UB4 / UB2 Shot Pins – Internal Hard Stop Enhancement

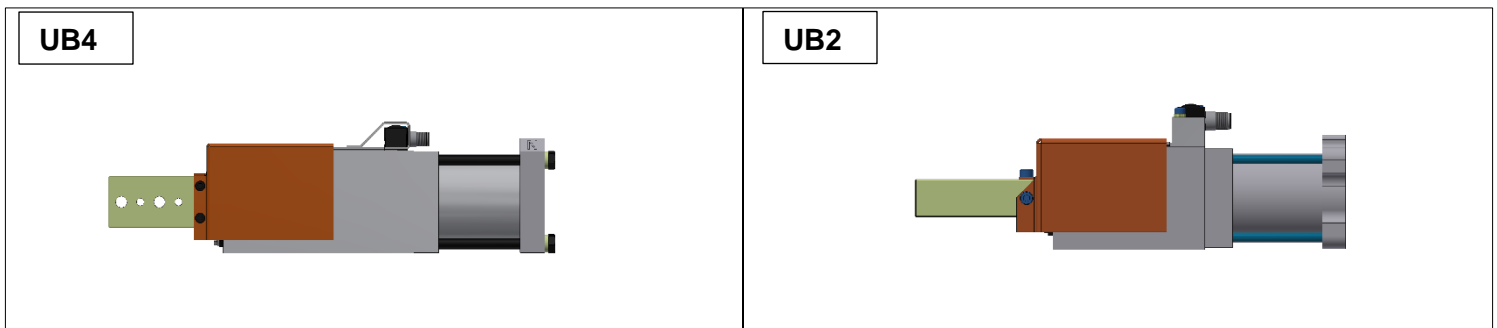
To meet the needs of our customers, we have enhanced the design of our UB Series Shot Pins with an internal hard stop to ensure end of stroke repeatability without the need for the Double Rod option and external hard stop.

1. You no longer need to order the 03 or 04 Pneumatic Double Rod option.
2. You no longer need to order option E adjustable extend stop, or G fixed extend stop.
3. New internal hard stop is capable of holding $\pm 0.05\text{mm}$ ($\pm 0.002''$) end of stroke repeatability.
4. Space savings is obtained without the Pneumatic Double Rod extension.
5. Rap or Rigid option is available for all models.
6. Under warranty you can still maintain Double Rod option on old units.
